N9938A-01

S E R V I C E N O T E

N9938A - FieldFox Handheld Analyzer

Figure 1: No sidebands issue

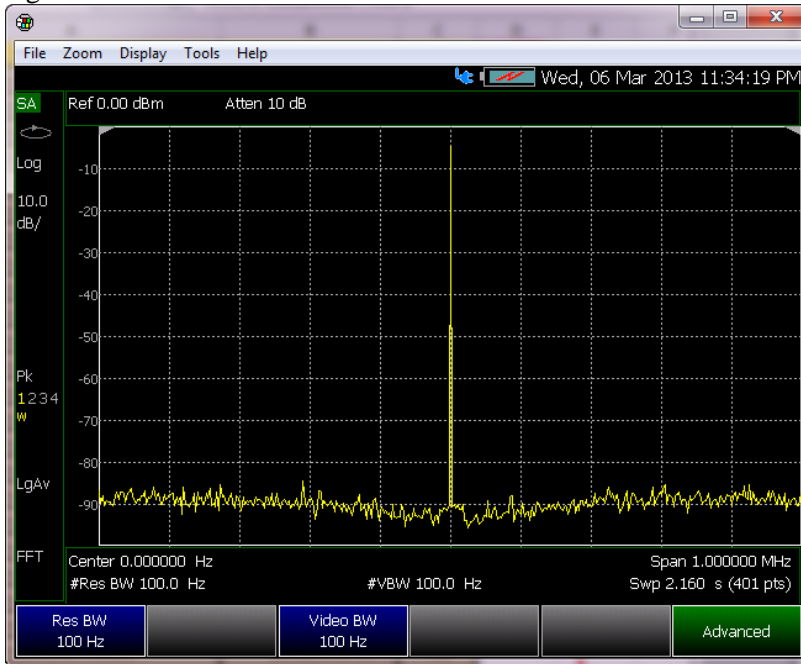
RF board earlier than Rev 7 may have sidebands issue due to oscillation by the voltage regulator. After it is fixed by replacing a new inductor, the RF board revision header will be updated to reflect the change.

Figure 1 shows a good RF signal, and Figure 2 shows FieldFox with sidebands issue.

Affected FieldFox are required to send back to Agilent factory for RF board reliability enhancement. The RF board revision header will be updated to reflect the change. Test and Adjustment shall be done before shipping back to customer.
